NO: SW-085
DATE: June 2010

PRODUCT: B3F Tactile Switches
TYPE: Material Change Notice

B3F (6 x 6mm): Notice of Tactile Switch Plunger Material Change

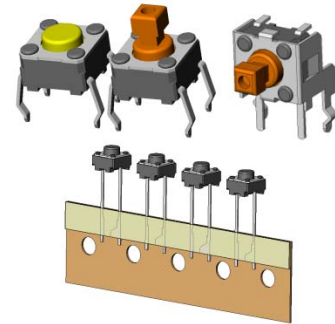
Effective as of **July 2010** production, plunger materials will change for most of the B3F-1000 series, with the following exceptions:

This measure was taken in order to *improve* heat resistance tolerance of the plunger at current soldering conditions.

Before the change	➔	After the change
<p>Material of plunger: PPO resin</p> <div style="text-align: center;"> </div>		<p>Material of plunger : PBT resin</p> <div style="text-align: center;"> </div>
